SUBJECT: ISSUANCE OF AMENDMENT FOR THE WASHINGTON PUBLIC POWER SUPPLY SYSTEM
NUCLEAR PROJECT NO. 2 (TAC NOS. M87076 AND M88625)

The Commission has issued the enclosed Amendment No. 137 to Facility Operating License No. NPF-21 for WPPSS Nuclear Project No. 2. The amendment consists of changes to the Facility Operating License and Technical Specifications (TSs) in response to your application dated July 9, 1993, as supplemented by letters of October 8 and October 25, 1993, January 6, January 6, February 2, May 3, May 13, September 26, and October 12, 1994.

The amendment increases the authorized maximum power level of the reactor from the current limit of 3323 megawatts thermal (Mwt) to 3486 Mwt. The amendment also modifies TSs to incorporate the increased power limit in the plant operating limits. This request is in accordance with the generic power uprate program for boiling-water reactors (BWRs) established by the General Electric Company and approved by the NRC staff in a letter dated September 30, 1991.

FIGURE 3.4.6.1B

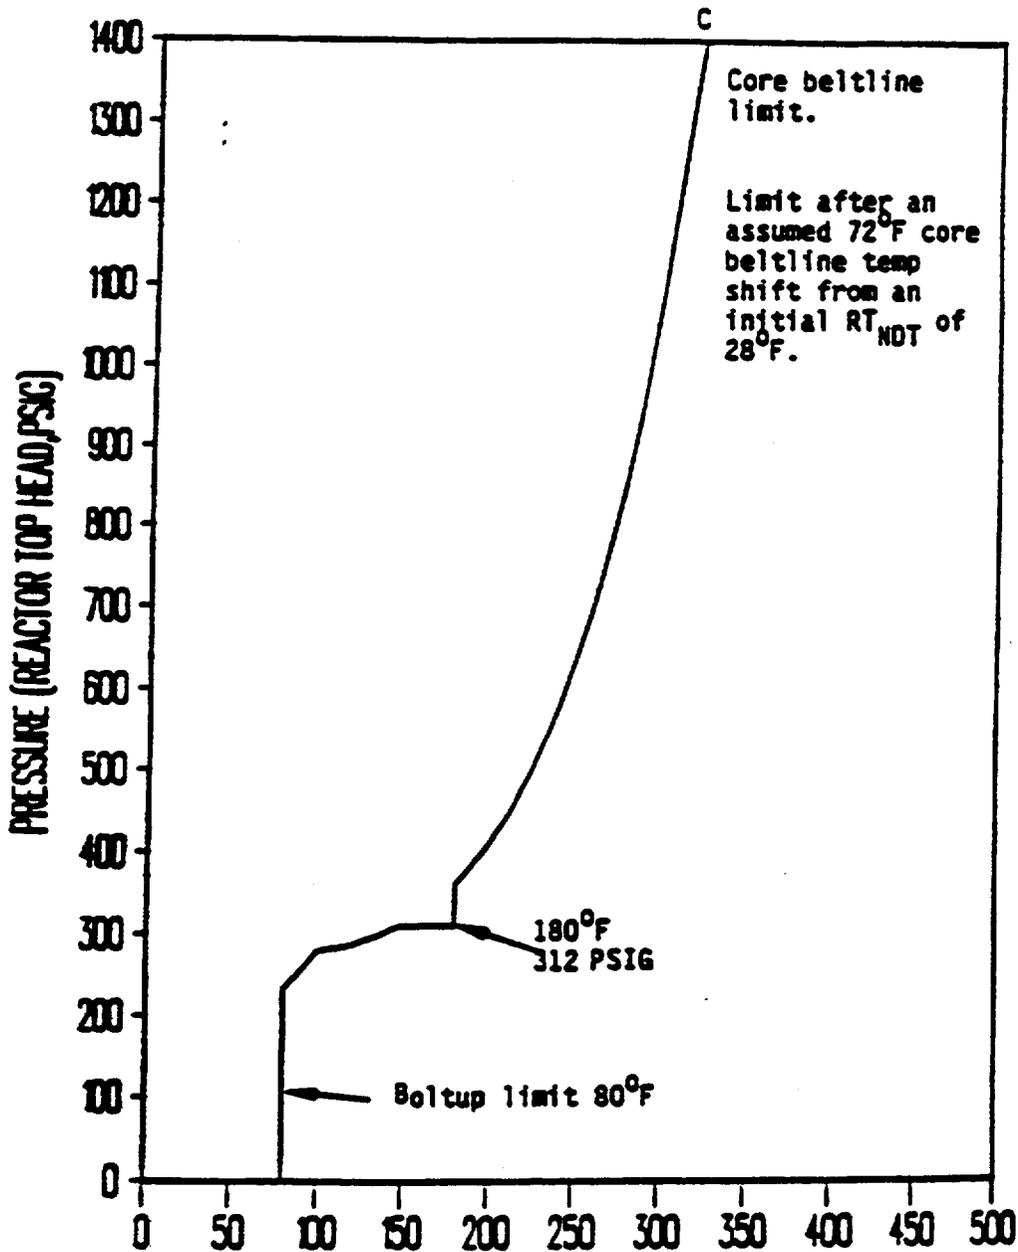
4.4.6.1.2 The reactor coolant system temperature and pressure shall be determined to be to the right of the criticality limit line of Figure 3.4.6.1B curve C within 15 minutes prior to the withdrawal of control rods to bring the reactor to criticality and at least once per 30 minutes during system heatup.
